REMARKS

Claims 1-31 are currently pending. Figure 4 is proposed to be amended as suggested by the Examiner. Applicants respectfully submit that entry of this Amendment is proper because it places the application in condition for allowance, or at least in better form for appeal. The allowance of claims 1-29 and indication of allowable subject matter in claim 31 are acknowledged with appreciation. Reconsideration is respectfully requested.

Fig. 4 CONVENTIONAL

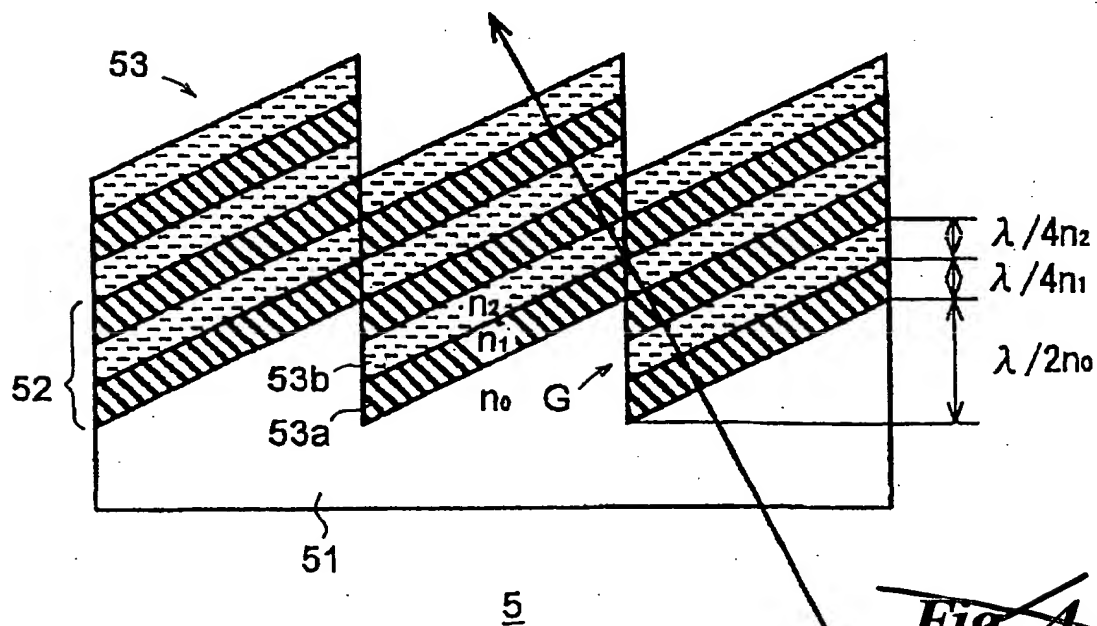
The Office Action includes an objection to Figure 4. Figure 4 is proposed to be amended to include the legend "Conventional" consistent with the Examiner's suggestion. Withdrawal of the rejection is respectfully requested.

The Office Action includes a rejection of claim 30 as allegedly being anticipated by Figure 4 of the present application. This rejection is respectfully traversed.

In the Amendment of June 20, 2003, Applicants pointed out that the structure illustrated in Figure 4 of the present application has a predetermined depth (G) of the depressions that is equal to the thickness of layer 53b plus twice the thickness of layer 53a, whereas one period of the layer structure is equal to the thickness of layer 53b plus the thickness of layer 53a. Accordingly, it was submitted that the predetermined depth (G) illustrated in Figure 4 is not an integral multiple of one period of the layers, and that the structure recited in claim 30 was distinguishable for at least this reason.

Thus, Applicants respectfully submit that Figure 4 does not disclose a diffractive optical element as claimed in claim 30. In particular, contrary to the Office's suggestion, Figure 4 does not disclose a structure with a physical predetermined depth of $\lambda/2$ or a physical thickness of one period of layers of $\lambda/2$. Rather, the physical predetermined depth G shown in Figure 4 is $\lambda/2n_0$, and the physical thickness of one period of layers is $\lambda/4n_1 + \lambda/4n_2$. In the structure shown in Figure 4, the physical predetermined depth G (i.e., $\lambda/2n_0$) and the physical layer period (i.e., $\lambda/4n_1 + \lambda/4n_2$) are not equal, because n_0 , n_1 and n_2 are not equal. Accordingly, Figure 4 of the present application does not illustrate a dielectric film comprising a plurality of layers having a physical thickness such that the physical predetermined depth is an integral multiple of one period of the layers as recited in claim 30. Withdrawal of the rejection and allowance of claim 30 are respectfully requested for at least this reason.
